Proposal of amendments to gtr 9 (Pedestrian safety)

ECE/TRANS/180/Add.9, Add.9/Corr.1 & 2 and Amend.1

Test area and Measuring point

Figure 6A: **Measuring impact and target point in the vertical longitudinal plane through the center of the impactor** (see paragraphs 3.30, 3.19, and 3.25.) *)

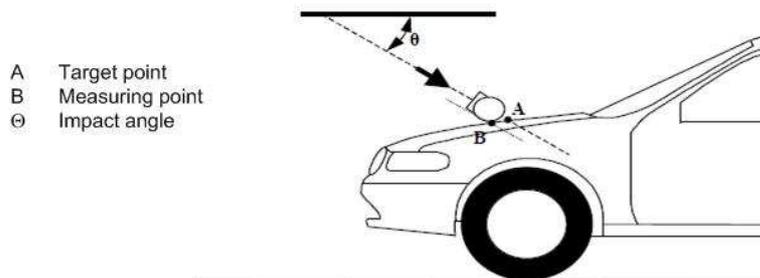
“3.25. “Target point” means the intersection of the projection of the headform longitudinal axis with the front surface of the vehicle (see point A in Figure 6A).

“3.30. The measuring point for the headform test is a point in the vertical longitudinal plane of the vehicle, containing the centre of the impactor. In this plane, it is the point at which the impactor nominally first contacts the bonnet top (see point B in Figure 6A and Figure 6B). The first contact point may differ from the measuring point as a result of the geometry of the bonnet top.”

Delete old figure 6 and add new Figures 6A, 6B, 6C as follows:

Figure 6B: Measuring and first contact point (see paragraphs 3.30. and 3.19.) *)

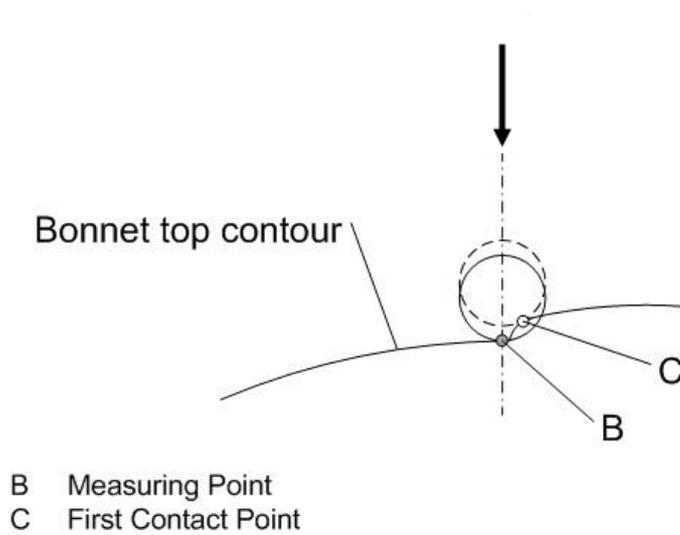
“3.19. ~~“Impact~~ **First contact point**” means the point on the vehicle where initial contact by the test impactor occurs. The proximity of this point to the target point is dependent upon both the angle of travel by the test impactor and the contour of the vehicle surface (see point C ~~B~~ in Figure 6B and Figure 6C).”

***) Remark: Due to the spatial geometry of the bonnet top, the first contact point C does, in most cases, not lie in the same vertical longitudinal or transverse plane which contains measuring point B**

Figure 6C: Measuring and first contact point (see paragraphs 3.31. and 3.19.)

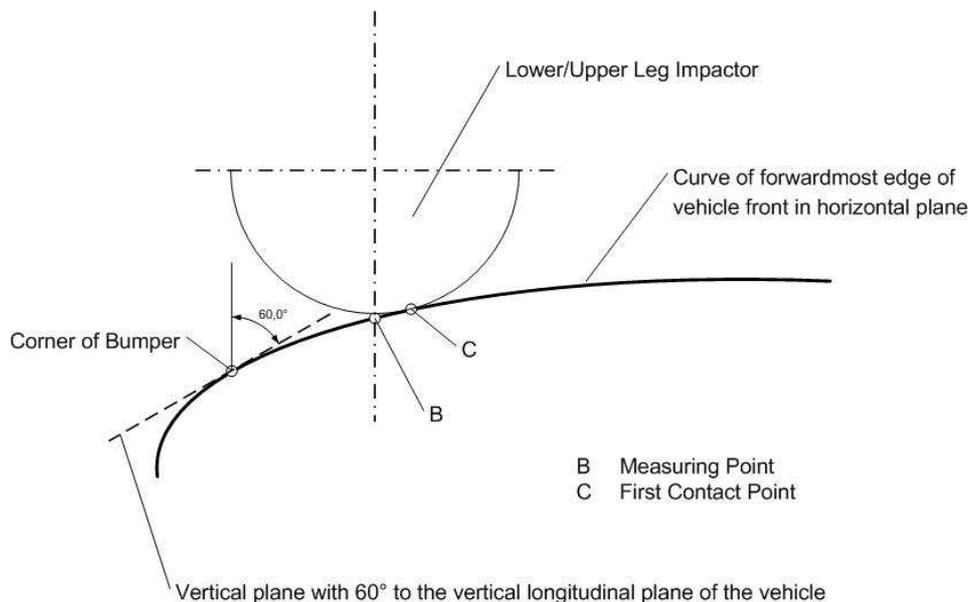
“3.31. The measuring point for the lower legform to bumper test and upper legform to bumper test lies in a vertical longitudinal plane containing the central axis of the impactor. The first contact point may differ from the measuring point as a result of the geometry of the vehicle front.”

Figure 11: Example of marking of HIC1000 zone and HIC1700 zone

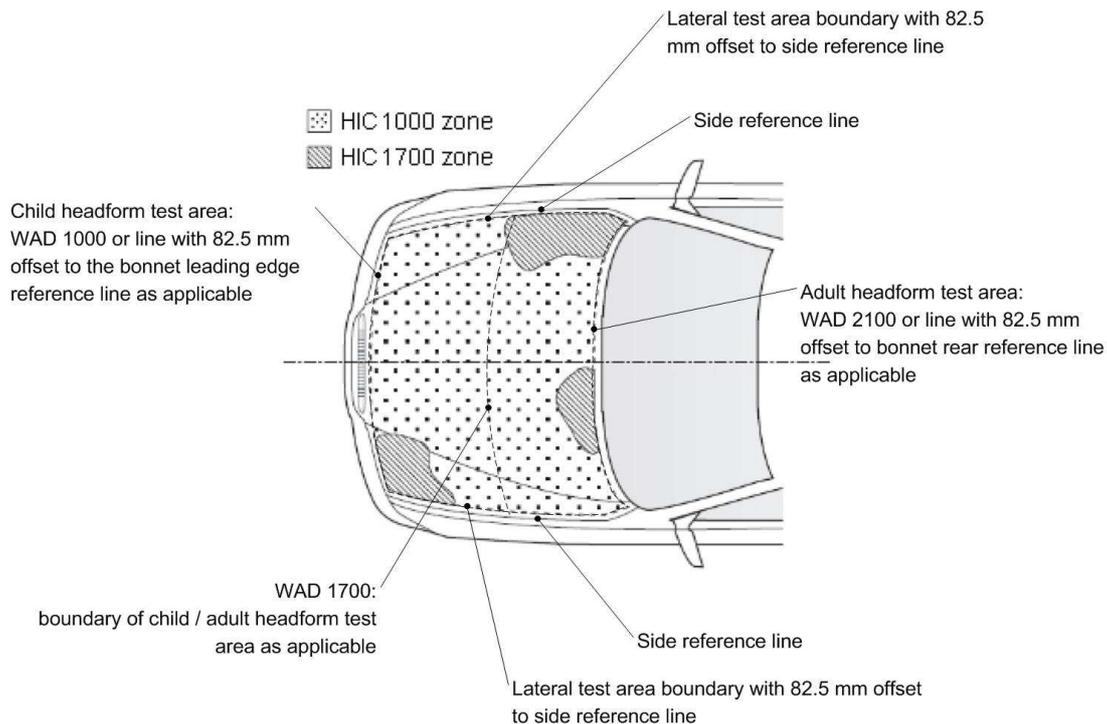
“5.2.4.1. The manufacturer shall identify the zones of the bonnet top **test area** where the HIC must not exceed 1,000 (HIC1000 Zone) or 1,700 (HIC1700 Zone) (see Figure 11)”

Delete old Figure 11 and replace it with the following new Figure 11:
